COA (SP) 2022-019  
August 17, 2022

**STAFF REPORT  
SPECIAL CERTIFICATE OF APPROPRIATENESS  
FOR THE PROPERTY AT  
1717 MADRID STREET  
A CONTRIBUTING RESOURCE WITHIN THE  
OBISPO AVENUE HISTORIC DISTRICT**

**Proposal:** The applicant is requesting design approval for additions and alterations to the residence and sitework. A variance has also been requested from Article 5, Section 5-606 (A) 4 of the Coral Gables Zoning Code for the minimum rear setback for the placement of mechanical equipment.

1717 Madrid Street (1261 Obispo Avenue)

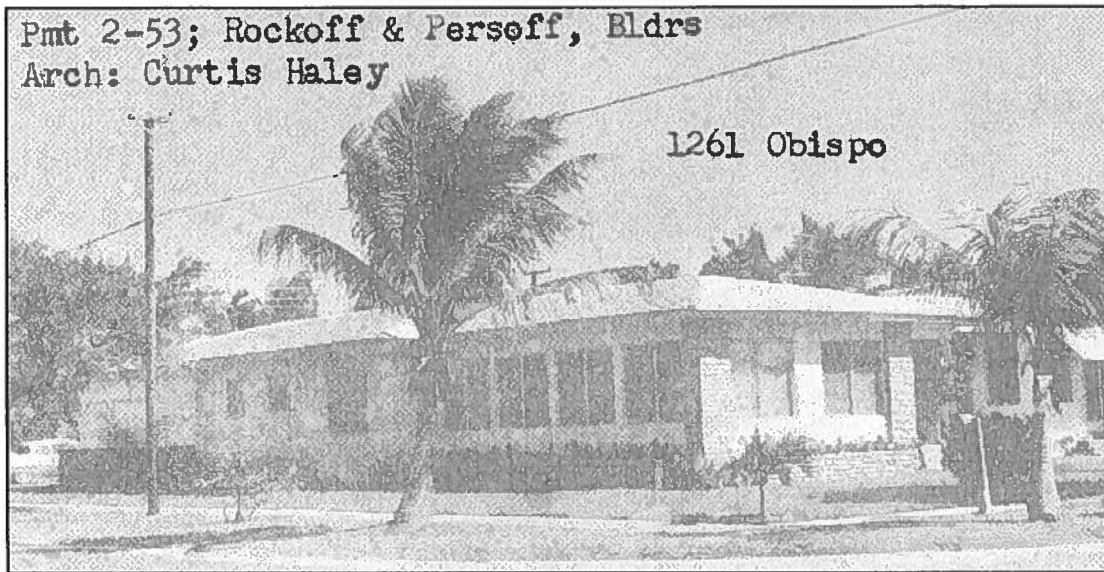
The primary façade faces west onto Madrid Street. As explained above, when first constructed the primary elevation with the main entrance was located on Obispo Avenue. The existing entrance door on this elevation will be relocated towards the center of the elevation. The new door will be a recessed double door with a surround of slump brick to match the existing and new steps. Two windows and a planter will be removed to provide access to the new door; however, this section of the house appears to have been altered and the planter does not appear to have been part of the original design. A window will be inserted into the space of the existing front door which will restore this section of the structure to its original appearance with four windows. Decorative Bahama shutters will be installed in front of these windows. The screen wall in front of these windows will be removed. This can be supported as the wall is a later addition. The louvers of the garage will be replaced with windows to provide light to the extended living space. A new privacy wall will be attached to the garage to screen the rear yard. The wall will incorporate aluminum louvers of a similar design to those existing on the garage. Slump brick will be added to the lower section of the wall to mimic the existing slump brick.

This was originally the primary façade, which has been altered. The entrance door will be moved slightly to the west, a planter will be removed to provide access, and two new planters of slump brick will be installed on either side of the door. These alterations can be supported as the existing door is not in its original location.

The windows openings on the east elevation will be reconfigured. This can be supported as the original openings have been altered and this elevation is only minimally visible from the right-of-way.

The existing north elevation contains the entrance to the garage and French doors. The French doors are in the location of an original window. The garage door and French doors will be removed, and three sets of French doors will be installed to provide access to the rear yard area. A covered terrace comprising a hip roof of flat cement tile to match the existing tile supported by four steel columns with wood cladding will be attached to this elevation.

The applicant is requesting design approval for additions and alterations to the residence and sitework. All elevations have been subjected to some alteration in the past. The proposed relocation of the entrance door on the west elevation can be supported as, originally, there was no door on this façade, the proposed new location has been altered in the past, and the relocation will allow the reinstatement of an original window opening at the southern end of this elevation. The proposed new windows for the new interior living space in the existing garage will be inserted into the existing louvered openings and the new privacy wall screening the rear yard will incorporate louvered openings which mimic those of the existing garage. A clear delineation between the existing slump brick and the new slump brick on the rear yard privacy wall shall be incorporated. Removal of the existing screen wall from the front of this elevation will open up the corner of the house as originally intended. The south elevation has been altered and the existing door is not in the original location; therefore, the proposal to slightly move the new door can be supported. The reintroduction of slump brick detailing to this elevation can be supported. On the north elevation, the stucco shall indicate the outline of the original garage door. The new garage is appropriate in style and scale for the site and the district. The proposed alterations are in keeping with the Secretary of the Interior's Standards and the essential form and integrity of the historic district is unimpaired.

1. Details of the proposed windows and doors along with a window and door schedule shall be submitted to Staff for review.
2. All window and door glass shall be clear.
3. All window and door muntins shall be high profile.
4. The wall, fence, and gate heights shall be reduced to four feet.
5. Per Zoning comments, an access gate shall be provided on Obispo Avenue.
6. Details and specifications for the proposed wall, fence, gates, and light fittings shall be submitted to Staff for review.
7. A clear delineation between the existing slump brick and the new slump brick on the rear yard privacy wall shall be incorporated.
8. On the north elevation, the stucco shall indicate the outline of the original garage door.
9. All outstanding Zoning comments shall be addressed.
